CAUI-4 C2C Equalization control

In support of comments #22, #38, #39 and #41

Adee Ran, Intel Corporation

Without a management interface...

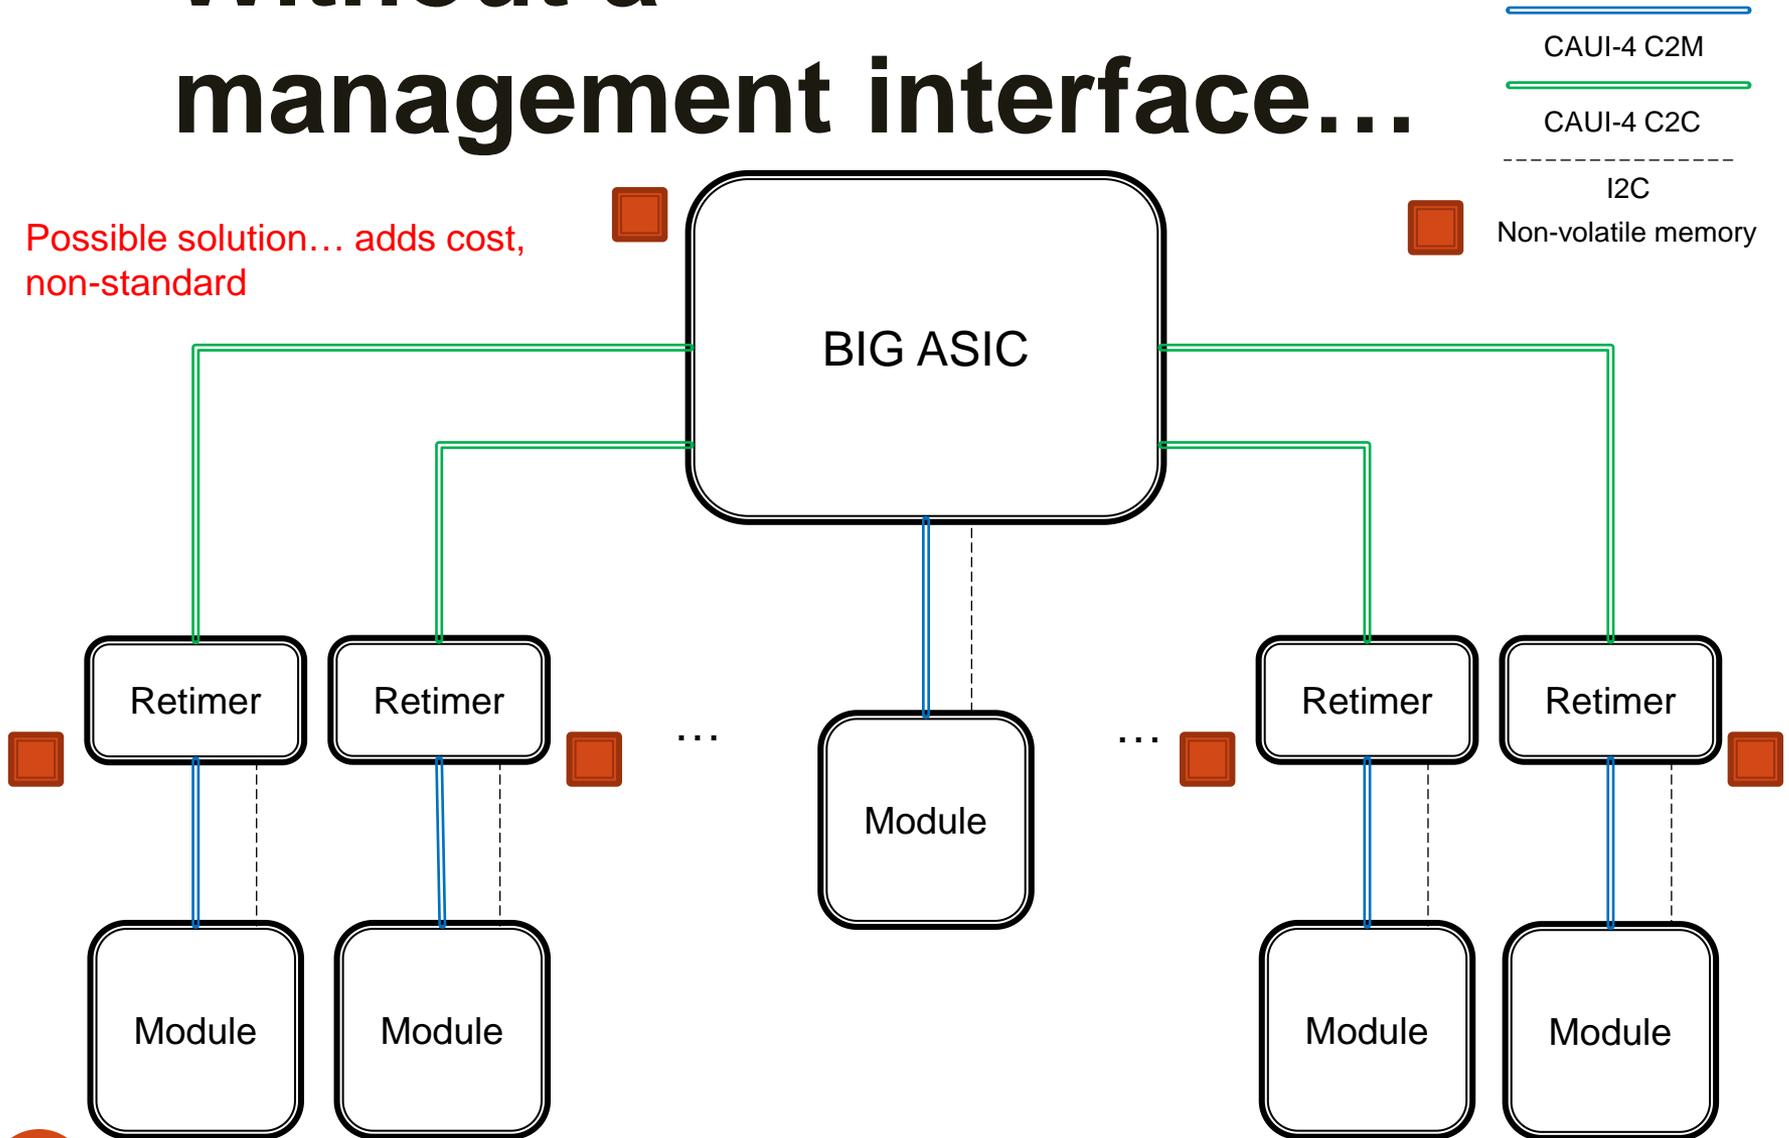
Each retimer controls a module using I2C (external specification).
But how are the retimers configured?

Possible solution... adds cost, non-standard

With MDIO

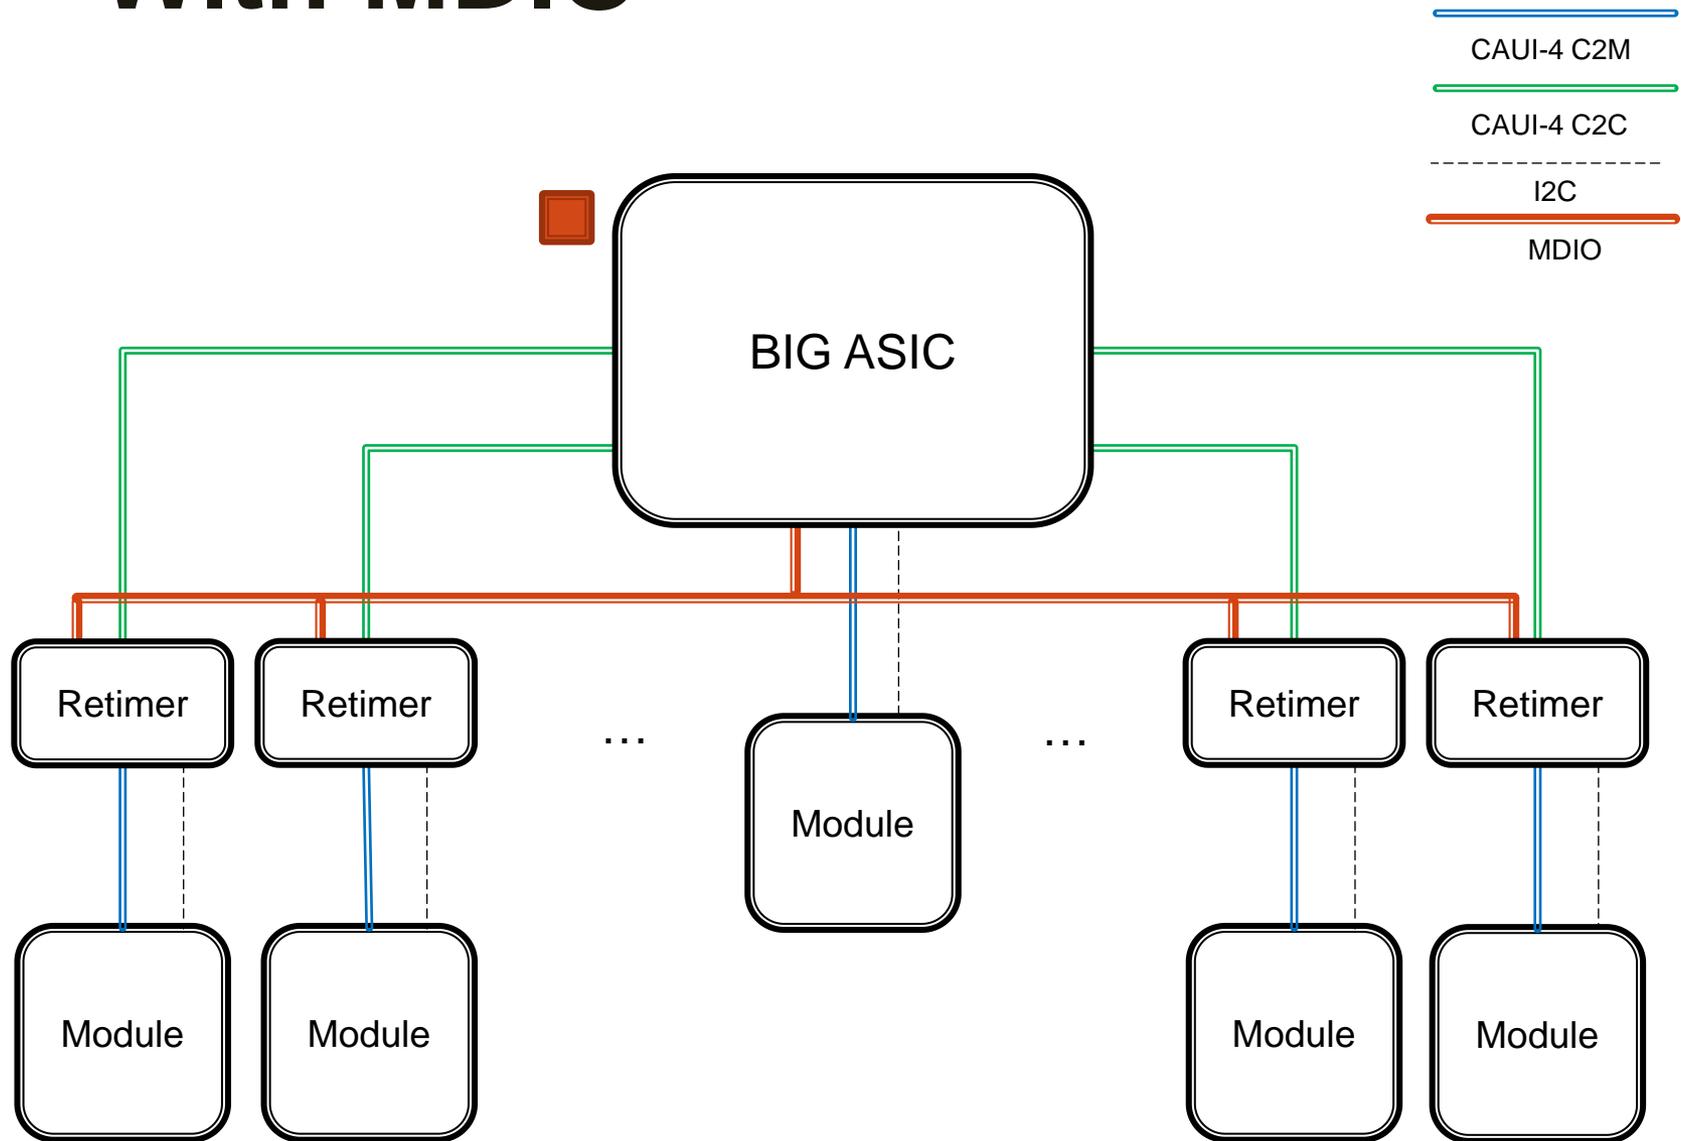
- A system can comprise several CAUI-4 C2C links and multiple “chips”.
- Separate chips with CAUI-4 C2C (such as Retimers¹) need to be programmed with transmitter equalization coefficients $c(-1)$ and $c(1)$ toward the CAUI-4 C2C partner.
- Settings depend on channel → likely to differ between chips and possibly between lanes.
- All these settings would be easier to manage if stored centrally and communicated to the chips in a standardized way. MDIO is a natural choice.

- Allocate MDIO registers for controlling CAUI-4 C2C equalization in a PMA/PMD device.
